CALIFORNIA COASTAL COMMISSION

TU 13m**RECORD PACKET COPY****STAFF REPORT: REGULAR CALENDAR**

APPLICATION NUMBER: 5-01-377

PROJECT DESCRIPTION: Construction of a stair enclosure structure on the existing roof deck of an existing two-unit multiple family residence.

EXHIBIT # 2

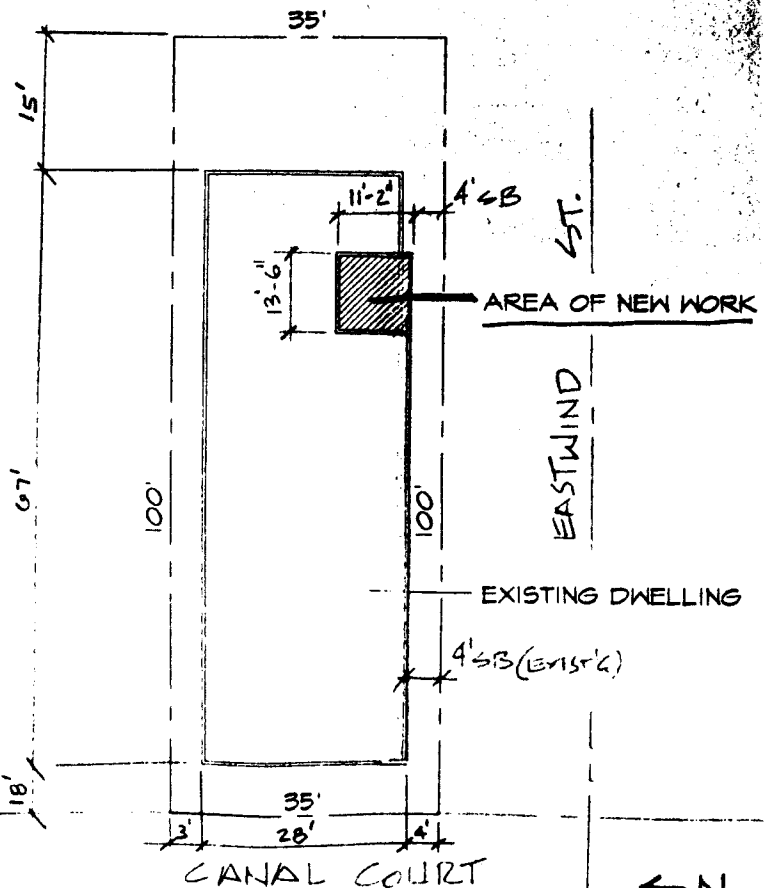
Roof access structures are permitted by the City's LUP provided that they do not exceed the specified flat roof height limit by more than ten feet. The proposed structure conforms to the LUP regulation limit. It will exceed the height limit by four feet. The second LUP standard for roof access structures requires that the roof access structure be designed and oriented so as to reduce its visibility from adjacent public walkways and recreation areas. The proposed structure is located on the Esplanade side of the building where it would be clearly visible from the Esplanade (City right-of-way) and the Canal, thus not conforming to the LUP (Exhibit #2).

The LUP also states that the area within the outside walls of the roof access structure shall be minimized and shall not exceed 100 square feet in area as measured from the outside walls. The proposed structure is 13'6"x11'2" (approximately 144 square feet), which does exceed the 100 square feet area limit and is inconsistent with the Certified LUP (Exhibit #2).

EXHIBIT # 3

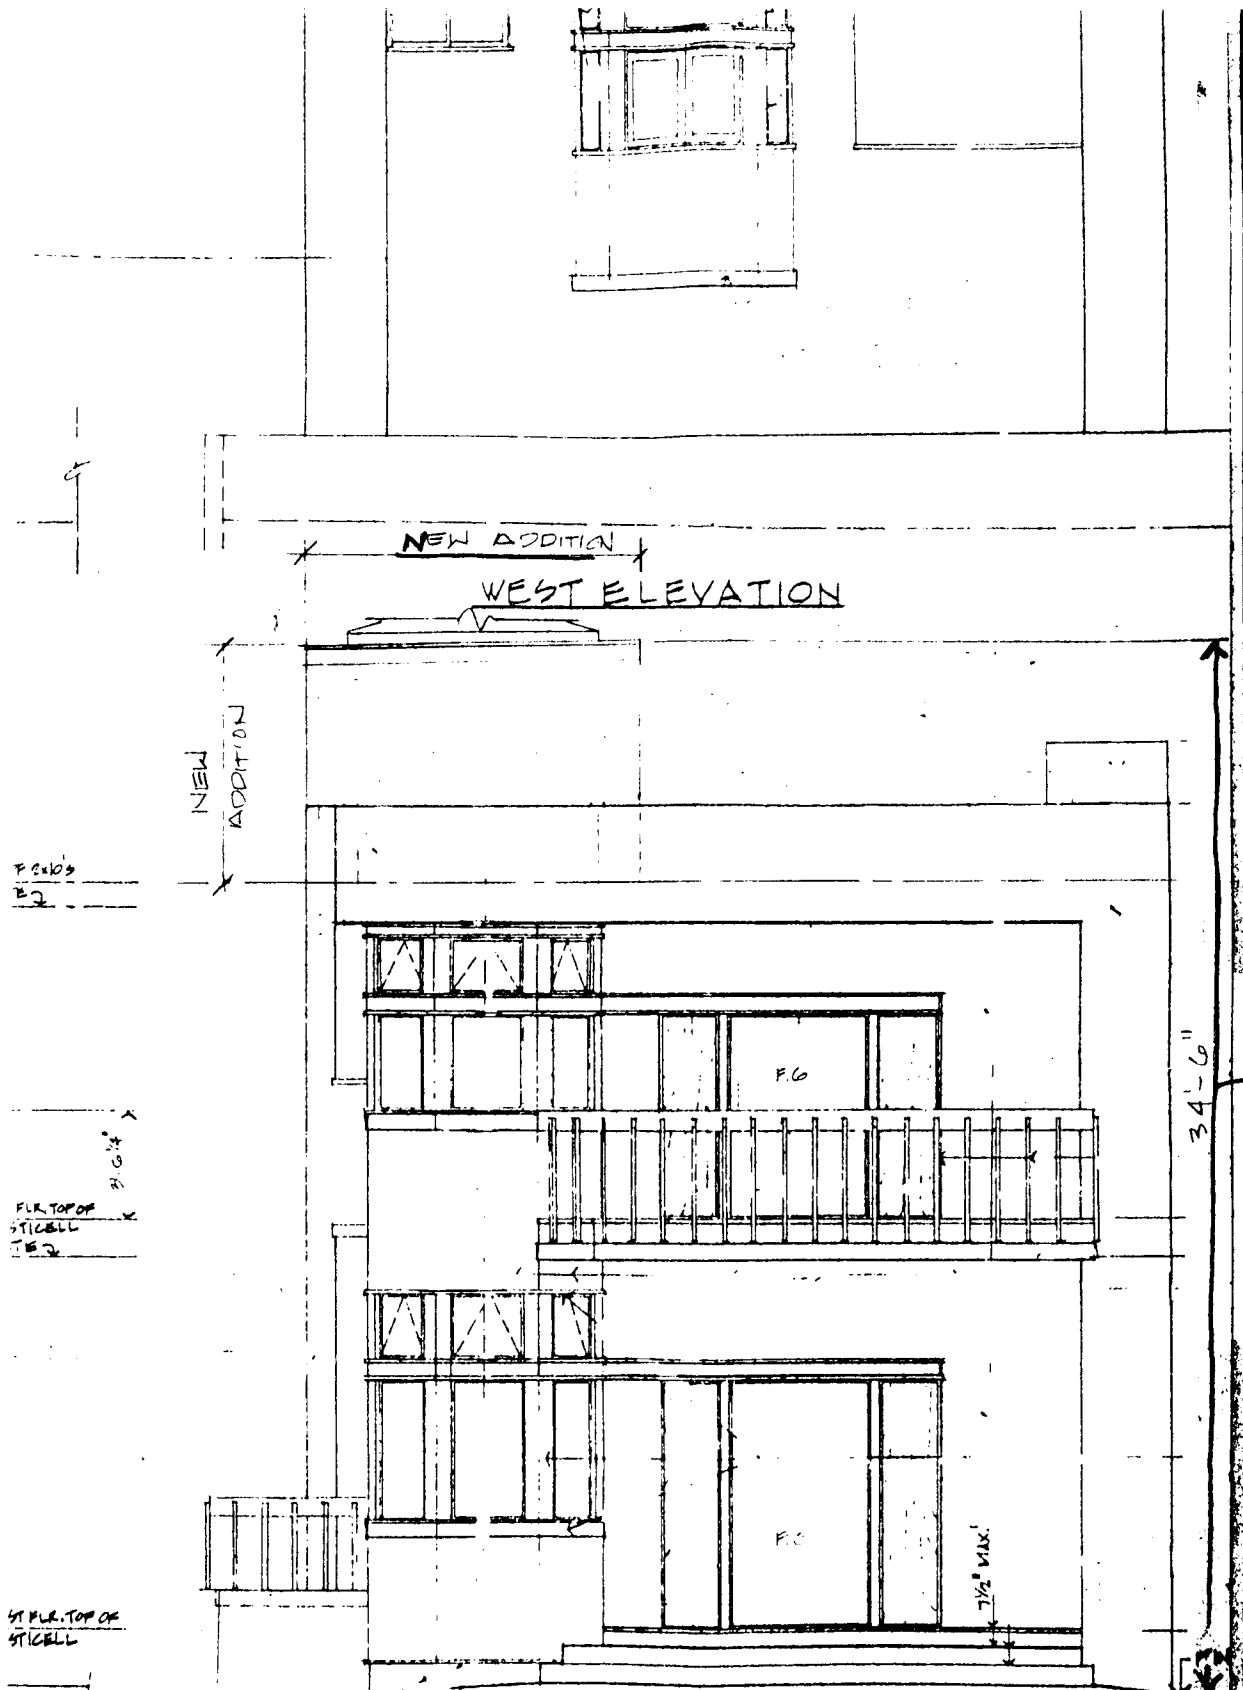
is to protect the building interior from leaks during rain. The proposed development would increase the height of the building from 30 feet to 34 feet (Exhibit #3). The existing two-story building is a two-unit multiple family residence located along the Grand Canal south of Washington Boulevard (Exhibit # 1).

EXHIBIT # 4
PAGE 1 OF 1

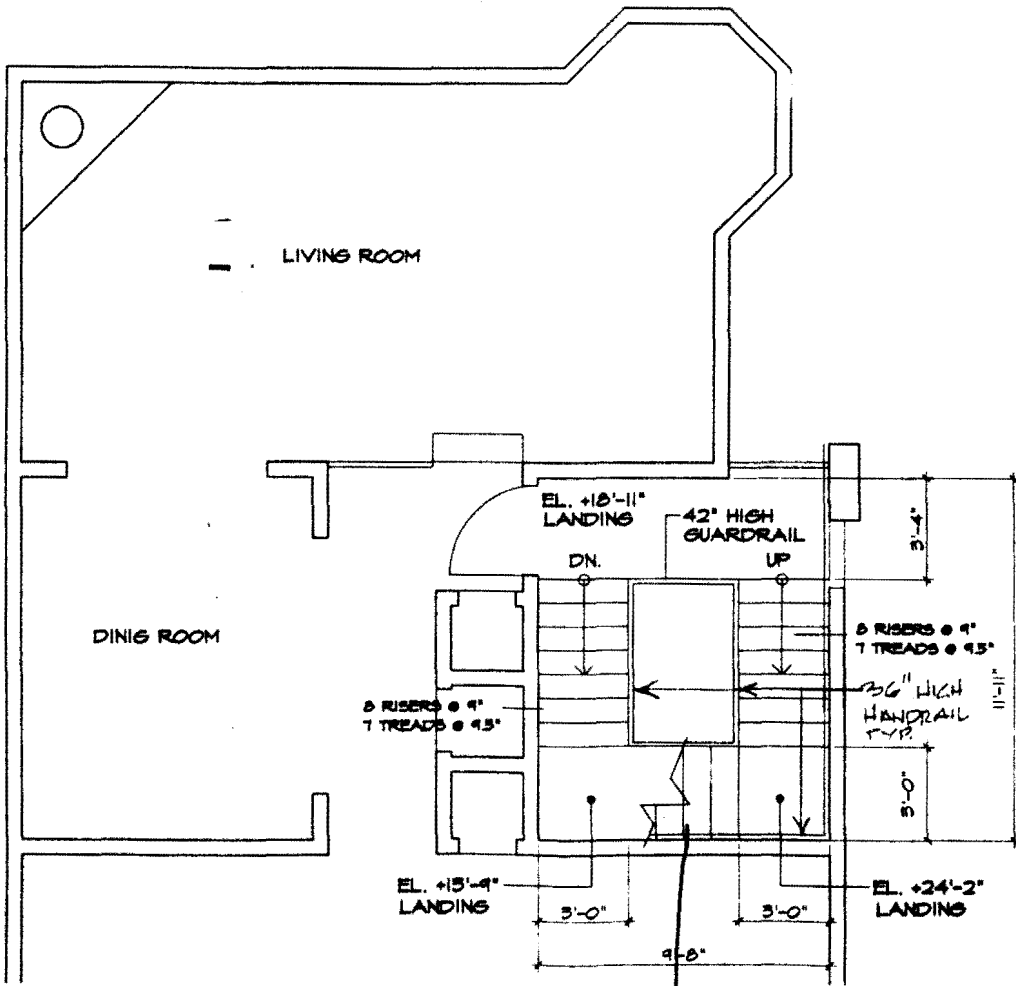
The applicant contends that he is not able to build the structure to conform to the City's LUP regulation standards for location and orientation because the internal staircase is existing so the access structure cannot be built in any other spot on the roof deck (Exhibit #4). The applicant contends that over the years, the existing roof access cover has deteriorated and now leaks into both existing apartments during rain. There are existing buildings across the canal and adjacent to this building that exceed the 30-foot height limit. The applicant contends that if conditioned to do so by the Commission, the square footage of the outside wall area would be reduced to comply with the LUP 100 square foot area maximum. The applicant contends that the outside walls of the proposed structure are to be made with stucco that will match the existing walls of the building, and the east side of the development (Esplanade side) is to be the more narrow of the two sides. The applicant did receive approval from the City of Los Angeles for the proposed development.
